Service Bulletin issued for
Circulation All Distributors
and Retailers

Section H
Bulletin No SY/H18
Page No 1 of 7
Date 2/9/71

LONGER FRONT SHOCK DAMPERS

All Rolls-Royce Silver Shadow and Corniche cars, and all Bentley T Series and Corniche cars from Car Serial Number SRH 11466 and onwards.

Fig. 1 Displaced and new shock dampers

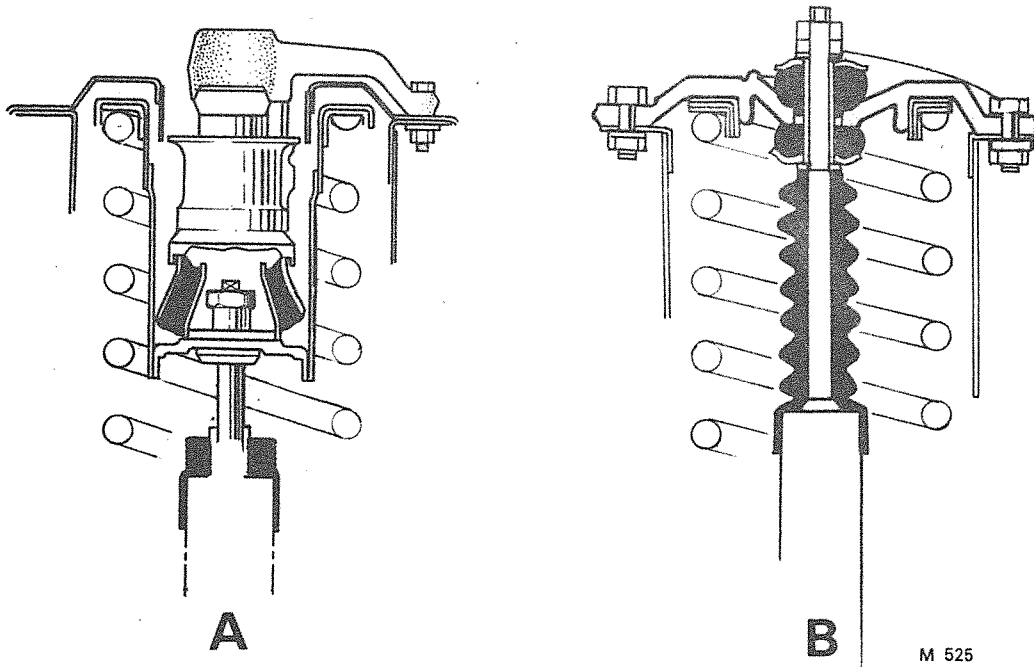
Longer front shock dampers have been introduced on the above cars to reduce the damper bearing side load. This reduction in load is effected by increasing the span of the rod guide and piston bearing.

At the same time the opportunity has been taken to simplify the upper mounting point, deleting the ram and the isolator etc. The longer shock damper now mounts directly into a top cover plate bolted to the spring pot tower (see Fig. 1). The methods of attaching the spring to the shock damper and the shock damper body to the lower triangle remain unchanged.

- (a) The new top cover (UR 17050) is used to replace the old top cover, ram and isolator.
- (b) Earlier cars fitted with front height control have the levelling system blanked off as described in Service Bulletin SY/G37.
